UNITED STATES PATENT AND TRADEMARK OFFICE

APPLICATION NO.	FILING DATE	FIRST NAMED INVENTOR	ATTORNEY DOCKET NO.	CONFIRMATION NO.
10/566,636	05/05/2006	Werner Lorch	D4700-00419	7412

Office Action Summary	Application No. 10/566,636	Applicant(s) LORCH, WERNER	
	Examiner AARON DUNWOODY	Art Unit 3679

DETAILED ACTION

In regards to claim 1, in Figure 1 below, Bosio discloses a holding device for a shower hose, comprising:

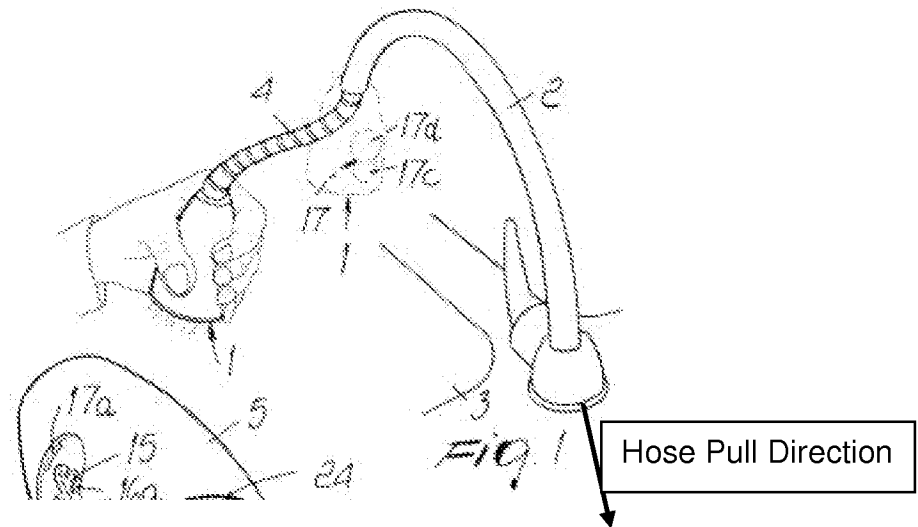
a feed-through element (2), a shower hose led (4) through the feed-through element, wherein the shower hose can be pulled longitudinally out from the feed-through element to a position at which the hose can be retained by a retaining mechanism (1), and from which the hose can be retracted back through the feed-through element,

wherein the retaining mechanism is disposed at the feed-through element for securing the shower hose against movement in one direction, has a detachable coupling (6a) for coupling and decoupling the shower hose with the retaining mechanism, wherein the retaining mechanism allows the shower hose to be pulled out, and when coupled prevents the shower hose from being pulled back, and when decoupled allows the shower hose to be pulled back, wherein the detachable coupling is actuated for said coupling and decoupling, manually by manipulation of the shower hose.

Applicant argues that Bosio does not disclose or suggest any sort of retaining mechanism for securing the shower hose at a pulled-out position. The Examiner disagrees. In Figure 1 above, Bosio clearly illustrates a retaining mechanism.

Applicant argues that Bosio does not disclose or suggest any detachable coupling associated with the faucet or other feed-through element, that operates between the hose and the feed-through element, so as to couple with and thus arrest the hose at the pulled out position, and also to decouple with the hose and thus permit the hose to retract. The Examiner disagrees. Bosio clearly illustrates a detachable coupling 6a.

Applicant argues that Bosio does not disclose the shower hose can be pulled longitudinally out from the feed-through element to a position at which the hose can be retained by a retaining mechanism, and from which the hose can be retracted back through the feed-through element. The Examiner disagrees. Figure 1 clearly illustrates the shower hose can be pulled longitudinally out from the feed-through element to a position at which the hose can be retained by a retaining mechanism, and from which the hose can be retracted back through the feed-through element.

Applicant argues that Bosio's retaining mechanism is not disclosed as being disposed on or in the feed-through element. The Examiner disagrees. In Figure 1, Bosio's retaining mechanism is disclosed as being disposed on or in the feed-through element.
